DESIGN RF	DRAWN BY RF	DART AEROSPACE LTD HAWKESBURY, ONTARIO, CANADA	
CHECKED <i>[Signature]</i>	APPROVED <i>[Signature]</i>	DRAWING NO. DEO 9183	REV. B SHEET 1 OF 1
DATE 00.05.15		TITLE ADD SKIDTUBE P/N D2580-045	SCALE NTS
A	00.03.29	NEW ISSUE	
B	00.05.15	39.580 WAS 39.620

## DART ENGINEERING ORDER

AMEND DRAWING D2580 REV. C TO ADD D2580-045 ASSEMBLY

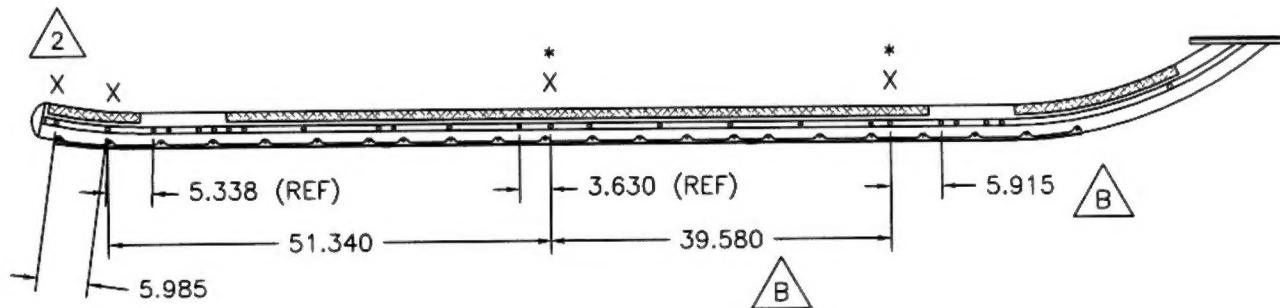
D2580-045 IS IDENTICAL TO D2580-041, EXCEPT FOR THE FOLLOWING CHANGES:

- 1) INSTALL CROSS BOLT SPACERS AT LOCATIONS MARKED 'X' ACCORDING TO THE FOLLOWING PROCEDURE.
  - a) DRILL  $\varnothing 0.508$  HOLES AT LOCATIONS SHOWN BELOW MARKED 'X'. CHAMFER HOLES  $0.030 \times 45^\circ$ . NOTE THAT HOLES WILL ALSO HAVE TO BE TRANSFERRED TO THE D2596 WEB AT THE \* LOCATIONS. IT IS ACCEPTABLE TO PRE-DRILL THE D2596 WEB IN THESE LOCATIONS BEFORE INSTALLING THE WEB IN THE SKIDTUBE. OPEN HOLES TO  $\varnothing 0.63$  AND TOUCH UP WITH ALODINE PER QSI 005 4.1.

- b) INSERT D2579 CROSS BOLT SPACERS INTO THE HOLES.
  - c) WELD INTO PLACE PER DART QSI 004 AND GRIND FLUSH.
  - d) REMOVE SPILL OVER LEAVING HOLE DIMENSION  $\varnothing 0.380-\varnothing 0.390$ .

- 2) IT IS ACCEPTABLE TO GRIND A RELIEF IN THE D2855 AFT CAP TO PREVENT INTERFERENCE WITH THE SPACER AT THIS LOCATION.
- 3) POWDER COAT ENTIRE ASSEMBLY GREEN (REF. 4.3.5.8) PER DART QSI 005 4.3 INSTEAD OF WHITE (REF. 4.3.5.1).
